<b>Delegated Report</b>		<b>Analysis sheet</b>	<b>Expiry Date:</b>	27/05/2021
		N/A / attached	<b>Consultation Expiry Date:</b>	22/05/2021
<b>Officer</b>			<b>Application Number(s)</b>	
Tony Young			2021/1594/P	
<b>Application Address</b>			<b>Drawing Numbers</b>	
Pavement on west side of Camden Road (adjacent to Canteloves Gardens) E:529601 N:184733 London NW1 9AE			Refer to draft decision notice	
<b>PO 3/4</b>	<b>Area Team Signature</b>	<b>C&amp;UD</b>	<b>Authorised Officer Signature</b>	
<b>Proposal(s)</b>				
Erection of 15m high electronic communications monopole with wraparound cabinet at base and 3 x equipment cabinets on the public footpath.				
<b>Recommendation(s):</b>	Prior Approval Required – Approval Refused			
<b>Application Type:</b>	GPDO Prior Approval Determination

- 1.1 Confirmation is sought as to whether the erection of 15m high electronic monopole with wraparound cabinet at base and 3 x equipment cabinets on the public footpath would require prior approval under Part 16 of Schedule 2 of the Town and Country Planning (General Permitted Development) (England) Order (GPDO) 2015 (as amended). The order permits the Council to only consider matters of siting and app

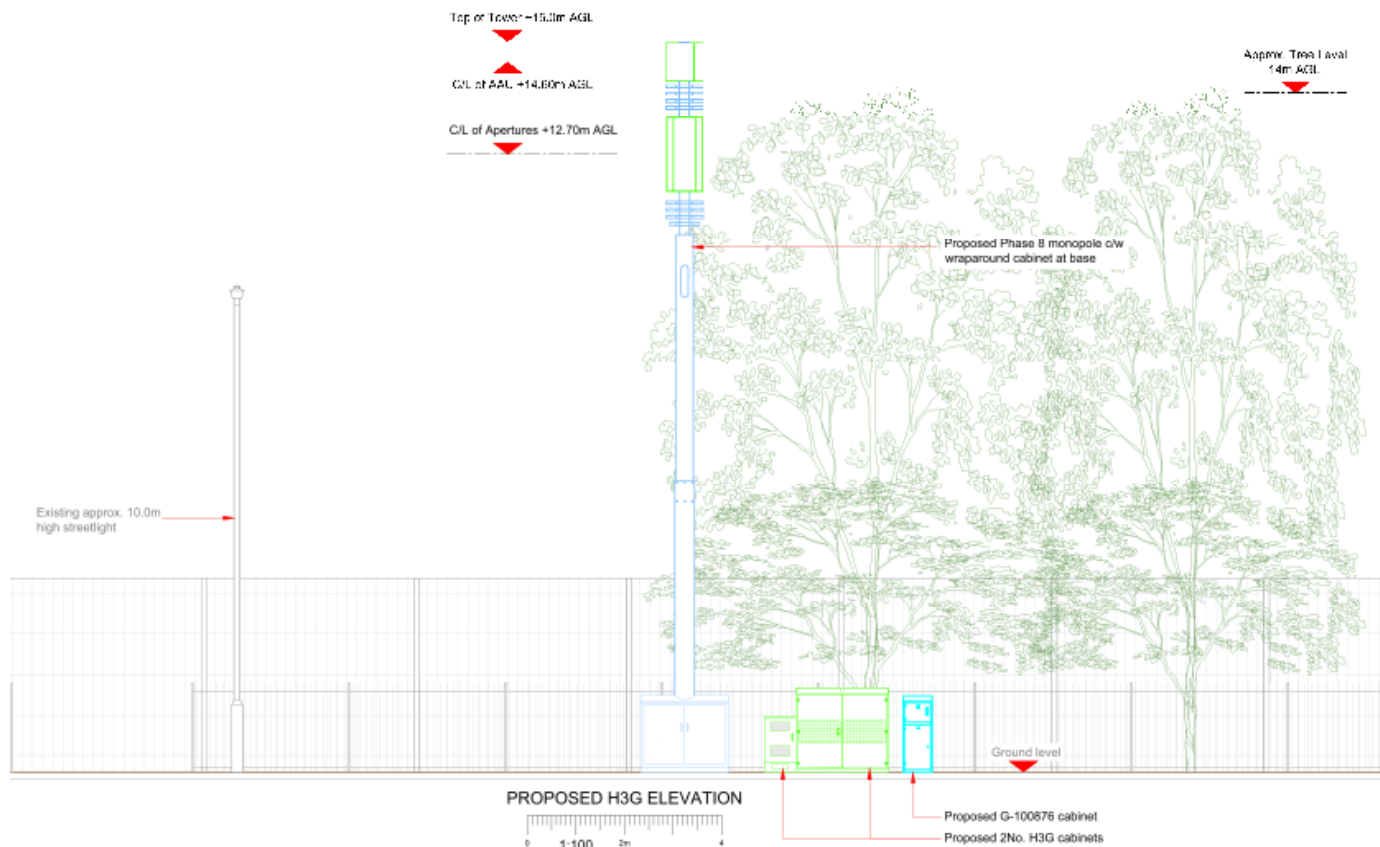
- 1.3 The proposal involves the erection of a monopole for electronic communications purposes measuring 15m high above ground level with various antennas (identified as A1, A2, B1, B2, C1, and C2) fitted at the top of the mast. The exact dimensions for the monopole width and full antenna dimensions have not been provided; however, the submitted drawings indicate that the monopole would have a width of approximately 0.4m. The antennas, fitted to the top of the monopole, would increase this appearance of width to approximately 0.8m at the highest part of the proposed monopole (see drawing '260 rev E - Proposed H3G Elevation' below):

1.4 The proposals include a large wraparound cabinet at the base of the monopole and the installation of 3 other cabinets on the public footpath on the north-western side of Camden Road (ref. CAB1, CAB2, CAB3 and CAB4).

1.5 The wraparound base station cabinet (CAB4) would measure 0.75m deep x 1.8m wide x 1.6m high. The other 3 cabinets would measure 0.6m deep x 1.9m wide x 1.752m high (CAB1); 0.7m deep x 0.65m wide x 0.95m high (CAB2); and 0.52 deep x 0.6m wide x 1.585m high (CAB3). All equipment would be grey in colour, although the exact RAL colour is unspecified.

- 4.6 The proposed monopole would be located on a stretch of pavement absent of any street furniture except for a 10m high lamppost and a traffic light (approximately 10m to the south-west) and a bus shelter (approximately 25m to the north-east). The mast would be significantly taller and wider than any these, and would protrude above the mature tree line canopy in Cantelowes Gardens and roof heights of buildings located directly opposite on the other side of Camden Road. The top 4m of the mast would be particularly prominent as it would accommodate the proposed antennas and extend the diameter of the mast to a width of approximately 0.8m at this point, so serving to heighten the mast's prominence even further and draw attention to the mast. As such, it is considered that the design and size of the proposed monopole would be visually dominant and incongruous in this context and be harmful within local views.

- 4.7 The applicant considers the proposed design will enable the equipment to blend into the surroundings as it has similar vertical lines and overall appearance to the existing street lighting columns. The Council disagrees with this view. While it is accepted that electronic communications equipment, by the nature of their functional design and aesthetic may not blend seamlessly in all environments, it is considered that the proposed structures, by virtue of their excessive size and scale, as well as, their prominent siting and number, would result in a proliferation of harmful visual clutter which would be unattractive and overly dominant on a section of footway along Camden Road which is relatively free of visual clutter.

4.26 The proposed monopole and associated cabinets would be located on a narrow section of footway adjacent to Canteloves Gardens on the north-western side of Camden Road. The footway width along this section is approximately 2.8m. The submitted drawings indicate that the proposed equipment would reduce the footway width to 1.84m during times when the doors to the most intrusively positioned street level cabinets are closed (and less than 1m when the same doors are open, for instance, during times of maintenance). The proposal would therefore reduce the effective footway significantly below the minimum widths recommended by both TfL and Camden guidance as referred to above.
